Department of Energy

TN-FSV SAFETY ANALYSIS REPORT INFORMATION

TN-FSV SAFETY ANALYSIS REPORT

TN-FSV SAFETY ANALYSIS REPORT ADDENDUM

Figure 2.11.2-1
Oak Ridge Container, Container Bottom Plate Finite Element Model,
with Boundary Conditions

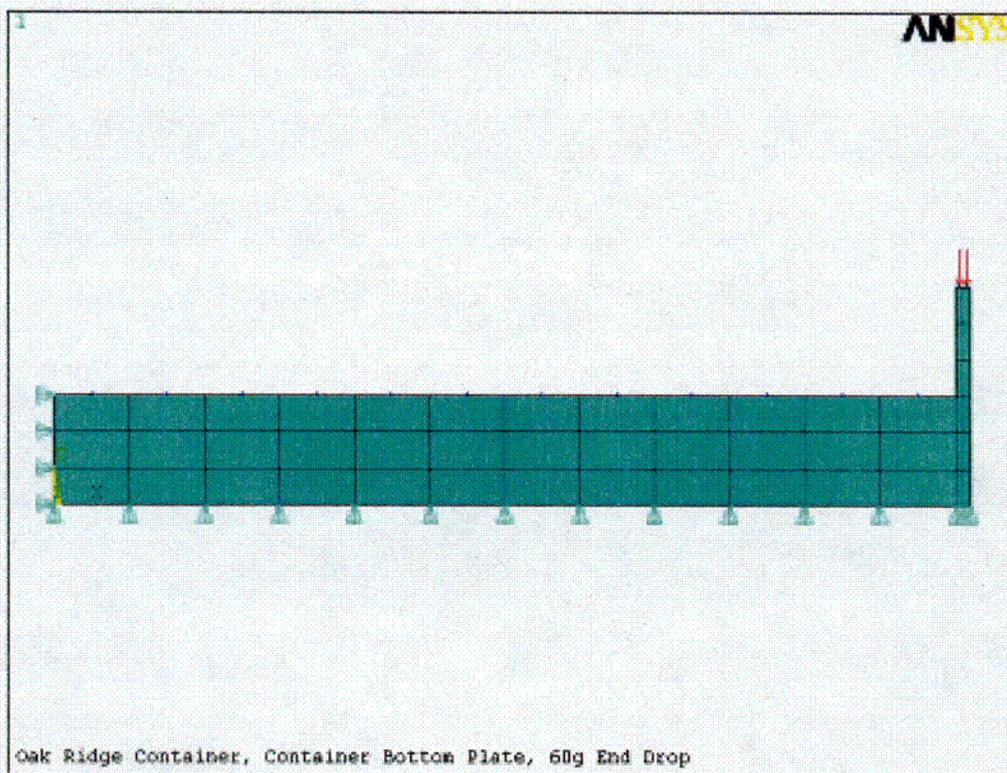
2.11.2-i	Added figures for ORC bottom analysis
2.11.2-9 thru 2.11.2-10	Added ORC bottom drop analysis.
2.11.2-12 & 2.11.2-13	Added figures for ORC bottom analysis

Figure 2.11.2-2
Oak Ridge Container, Container Bottom Plate Finite Stress Intensity,
due to 60g Bottom End Drop

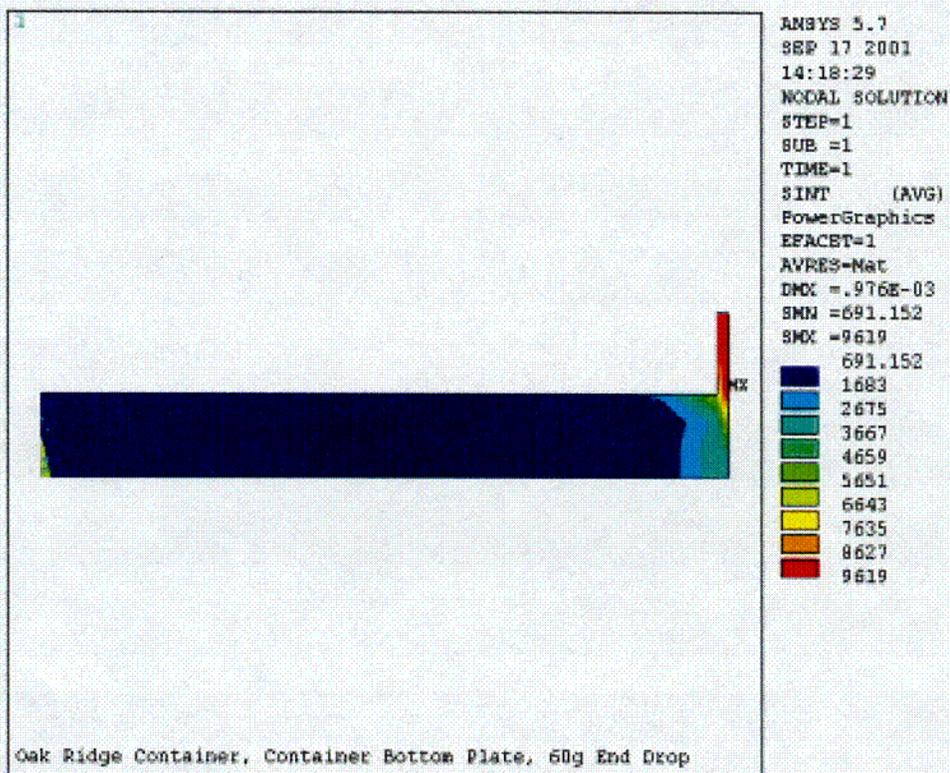
Figure 2.11.2-2 shows the stress intensity distribution computed by ANSYS. The maximum stress intensity in the container bottom plate is 9,619 psi., which is much less than the accident condition membrane stress allowable of 47,950 psi. This accident condition stress intensity is also less than the normal condition membrane allowable stress of 20,000 psi.
